**TOWN OF NEWBURGH
PLANNING BOARD
TECHNICAL REVIEW COMMENTS**

PROJECT: THE RIDGE (f/k/a THE LOOP)
PROJECT NO.: 17-01
PROJECT LOCATION: RT.300 & RT.52 SECTION, BLOCK & LOT: MULTIPLE
REVIEW DATE: 27 APRIL 2017
MEETING DATE: 4 MAY 2017
PROJECT REPRESENTATIVE: DIVNEY TUNG SCHWALBE, LLP

Re: The Hudson Valley Ridge (f/k/a The Loop)
Response to Orange County Dept. of Planning Comments
Project No. 17-01

PROPOSED SIDEWALK CONNECTION TO SLEEPY'S PLAZA

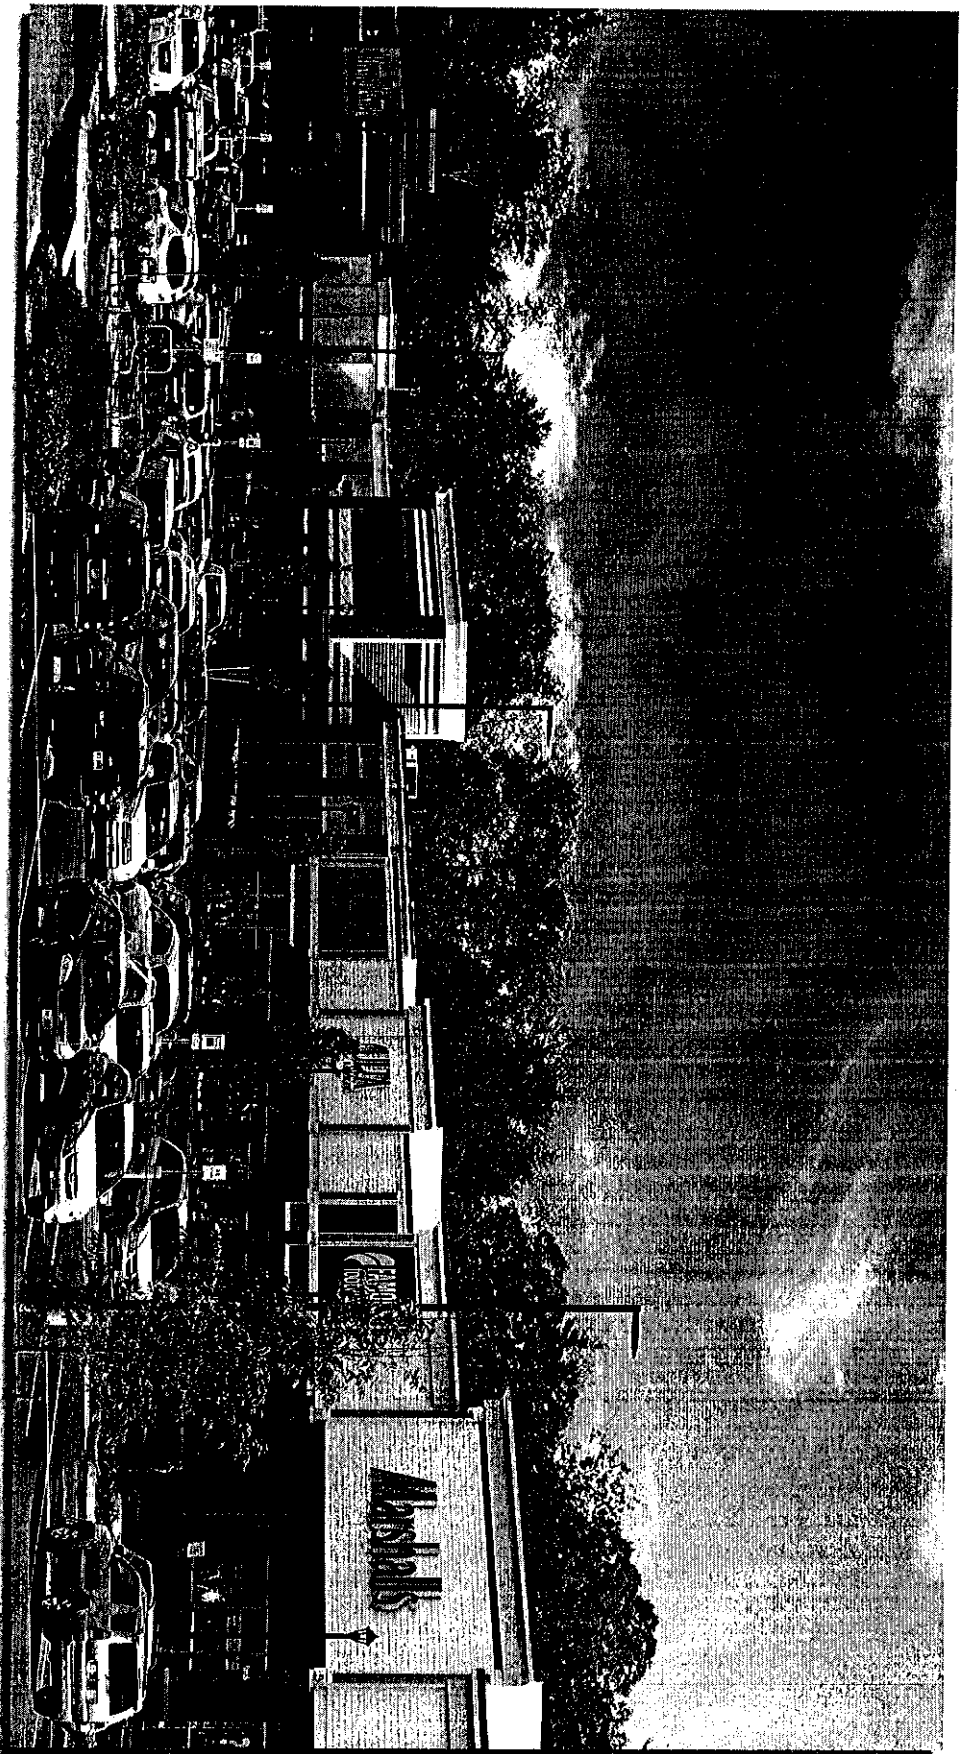
As a follow up to our discussion regarding the pedestrian accommodations for the above project, attached is a copy of the site plan showing the sidewalk which is proposed along the north side of the main entry driveway to Route 300. The sidewalk then extends along Route 300 to the north up to the property line to the adjacent retail complex. We have also provided a short segment connection to allow pedestrians a direct access to the parking area of this adjacent property. Note that this connection to the adjacent parking area also allows pedestrians to access the existing traffic signal located at the north end of this retail center.

SITE LIGHTING & MATERIALS

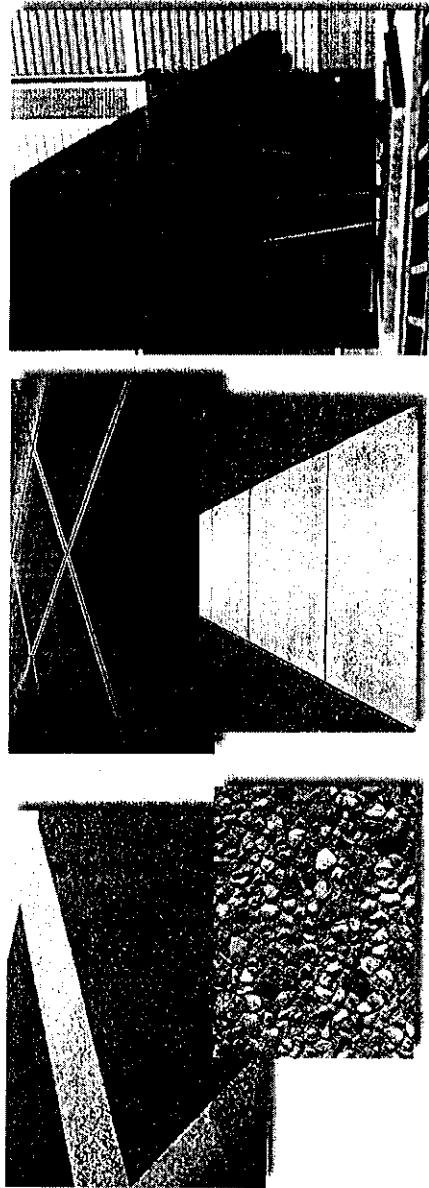
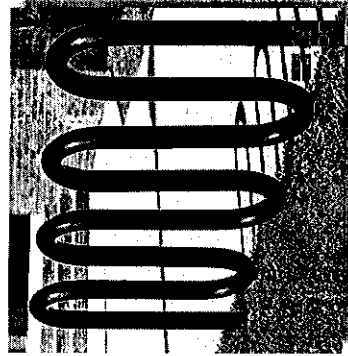
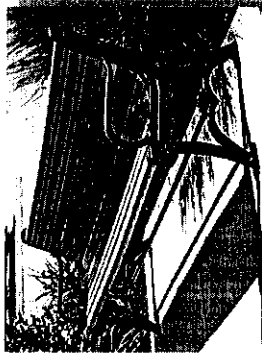
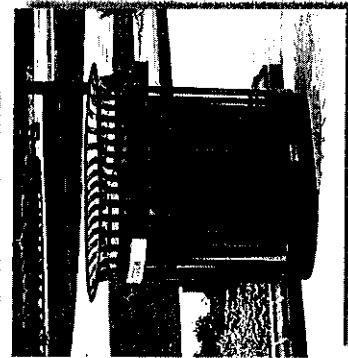
Street furnishings, sidewalk details, lights, planters, pergola, benches, trash cans and the like were included in the Conceptual Architectural Review Package submitted to the Planning Board as part of the pending Site Plan Amendment No. 6. Refer also to the attached excerpts from the 12/16/16 submittal to the Planning Board.

DESIGNED BY: MSG
PROJECT NO: 808
DRAWING NO: **SP-1.3**

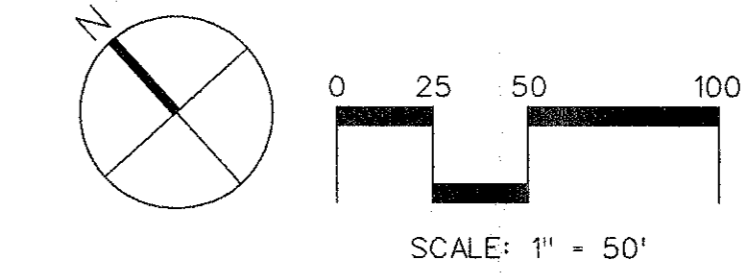
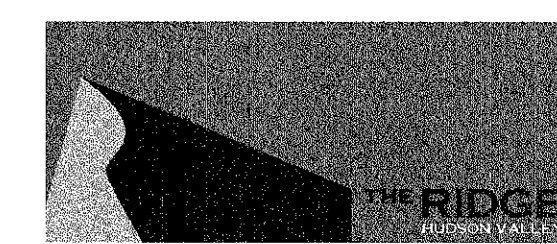
1. **Extension of the Road F/Gravel Maintenance Path** (Refer to attached Drawings SP-1.0, 1.3, 1.5, 1.7, 1.8, 2.3 and 3.0, last revised 4/4/17.)

2. **Brookside Avenue Improvements** (Refer to attached Drawings SP-1.3, 1.5, and 1.8, last revised 4/4/17.)

The Applicant proposes to complete all the Planning Board previously approved Brookside Avenue improvements, including the demolition of all existing structures as shown on the accompanying plans, prior to the Town's issuance of any certificate of occupancy for any structure within the retail center.

DESIGNED BY: MSG
 PROJECT NO: 808
 DRAWING NO: SP-3.0

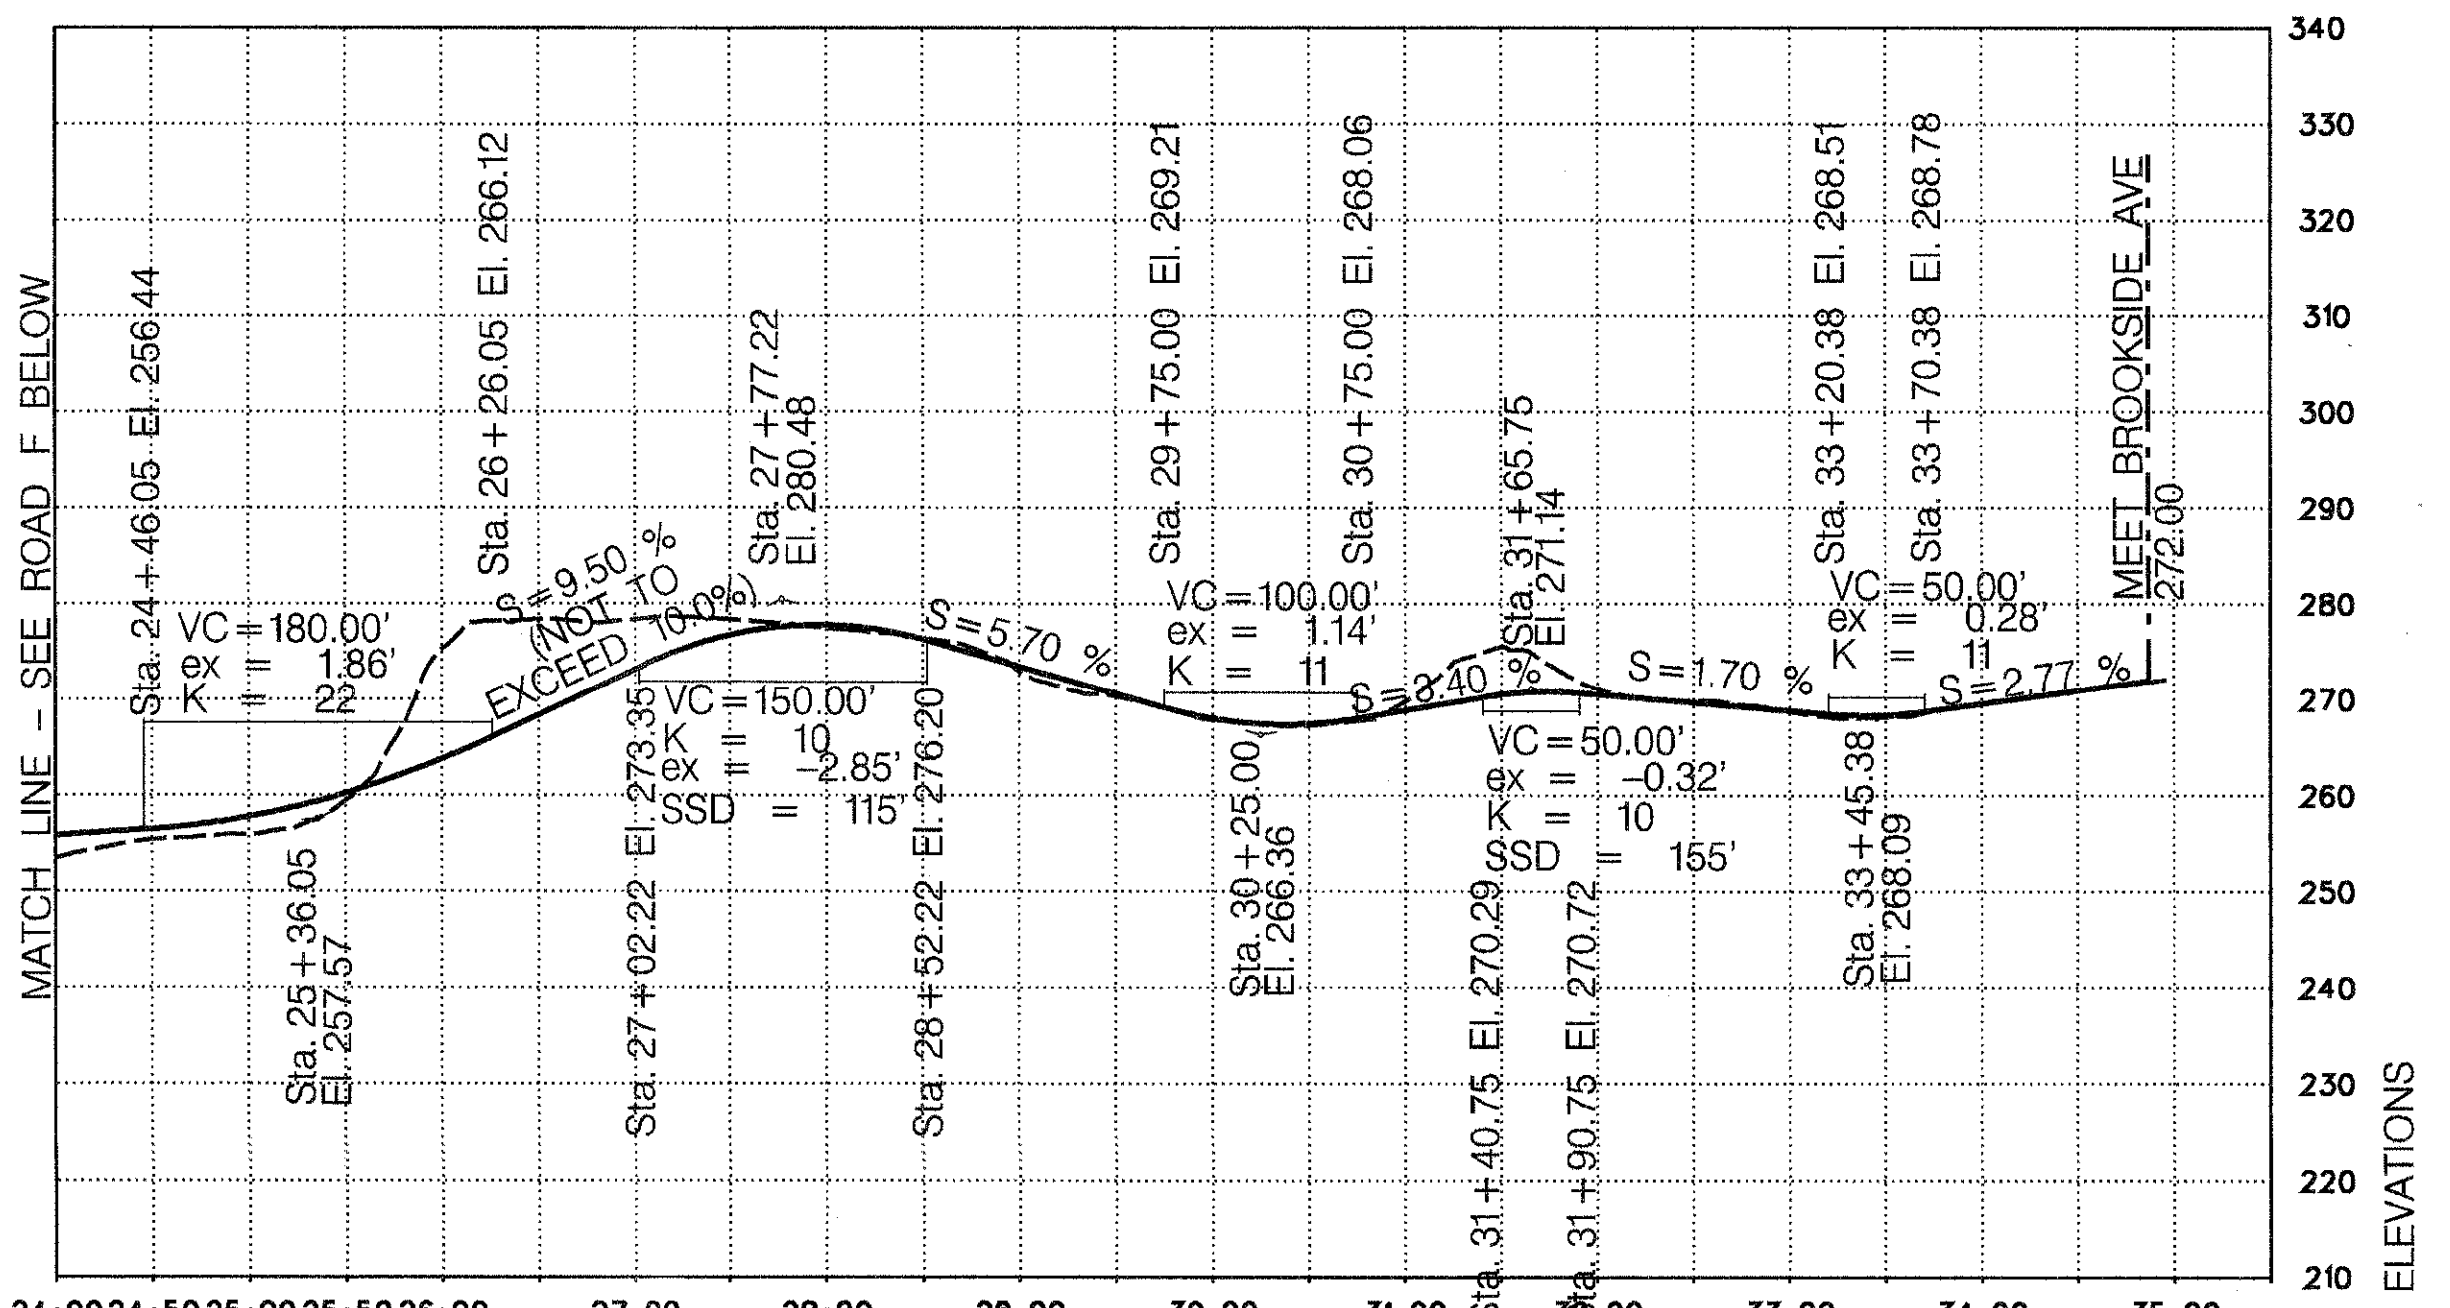
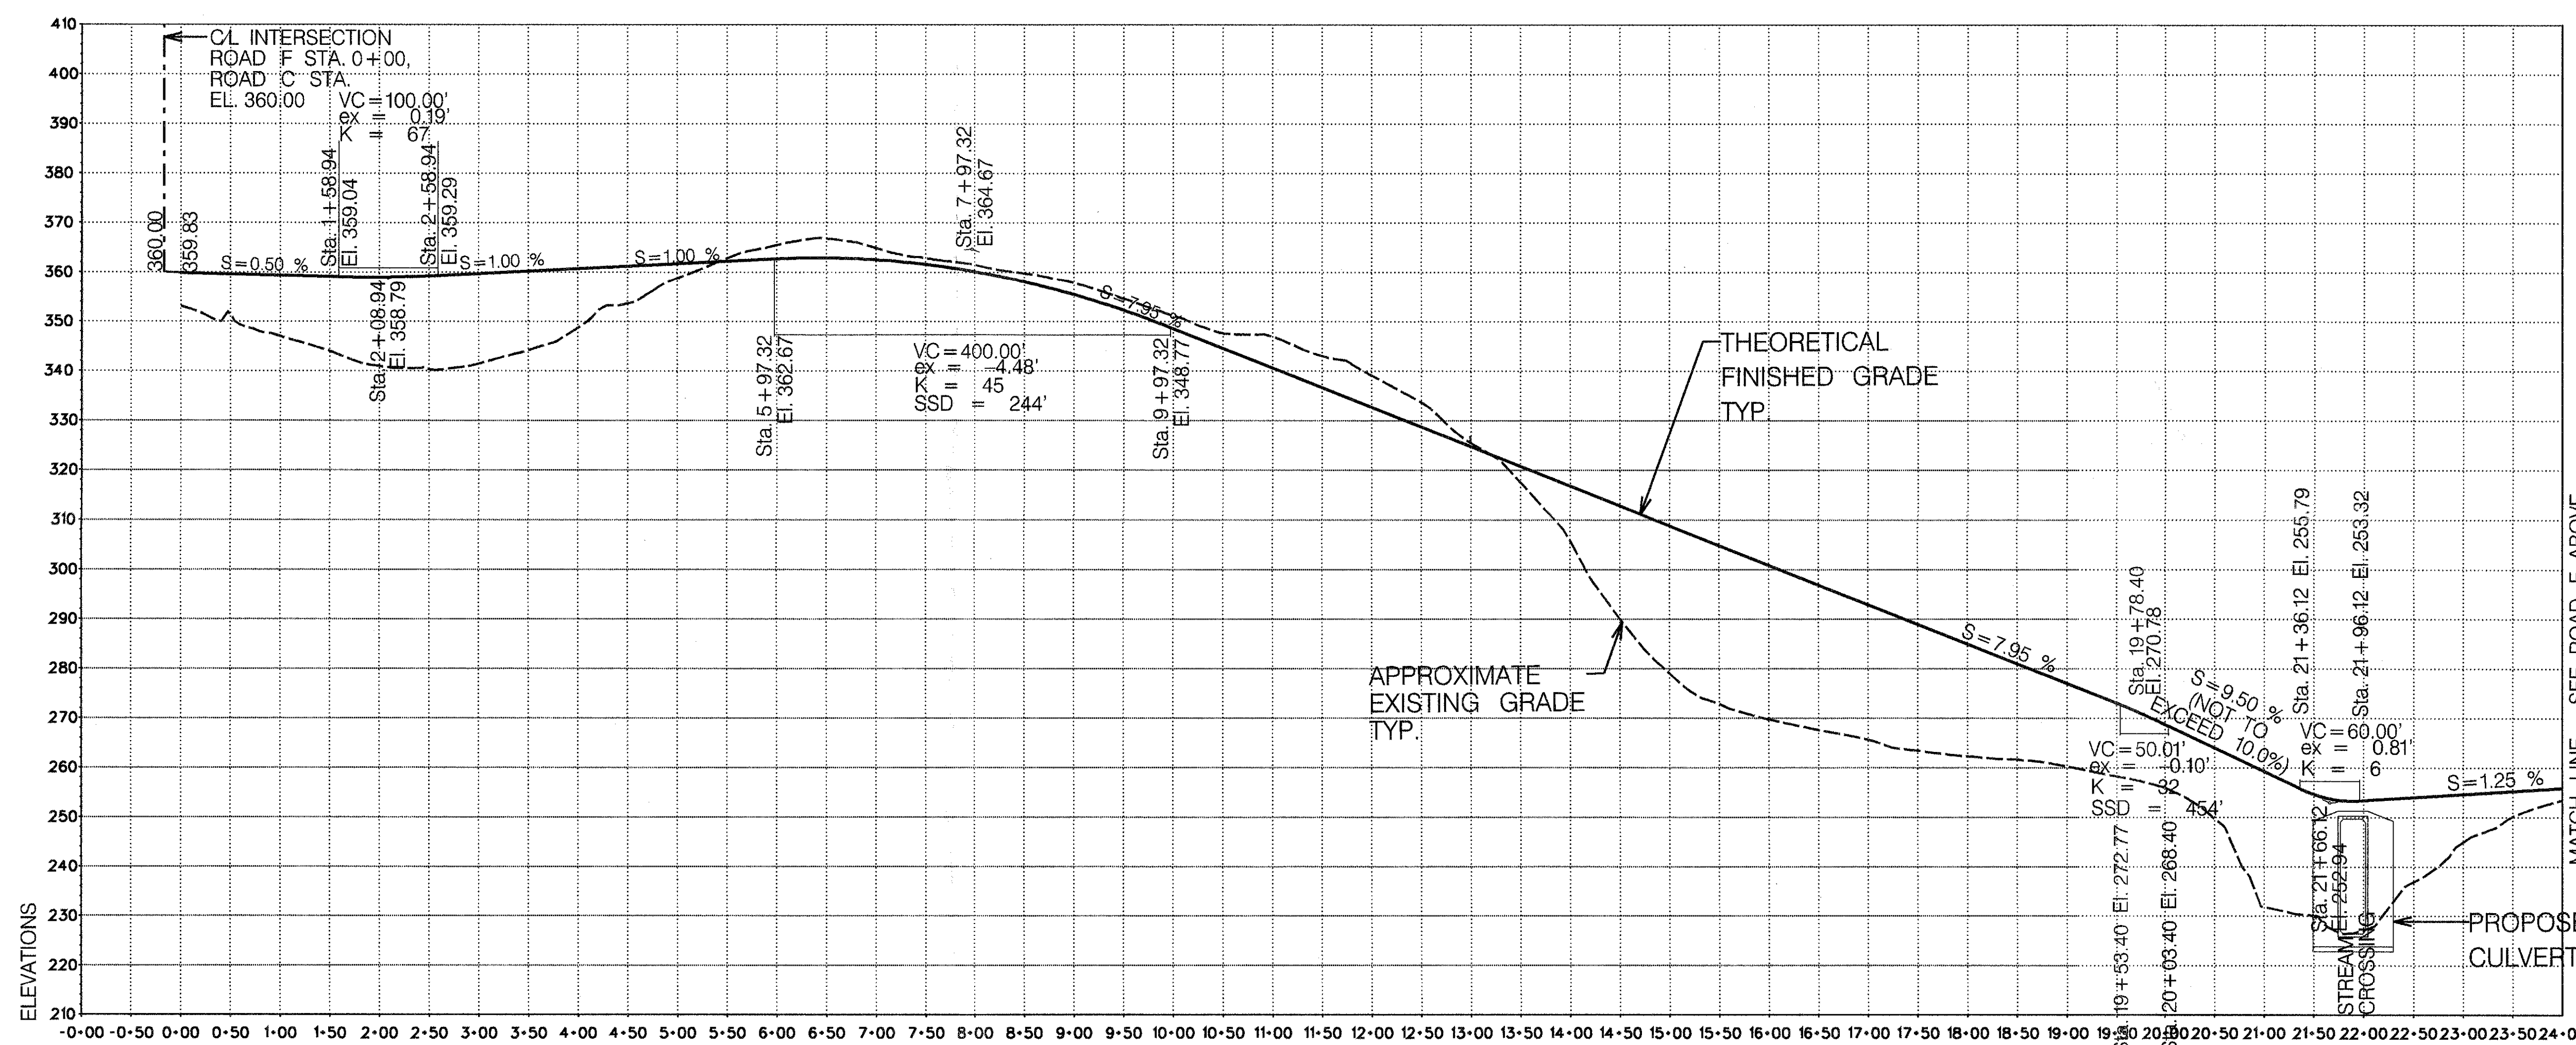
5. A gravel maintenance path has been labeled on the plans. This should be labeled as Emergency Access Drive to specifically delineate the area for Emergency Vehicle access to the site. Revised findings should address long term maintenance of the Emergency Access Drive during all weather conditions.
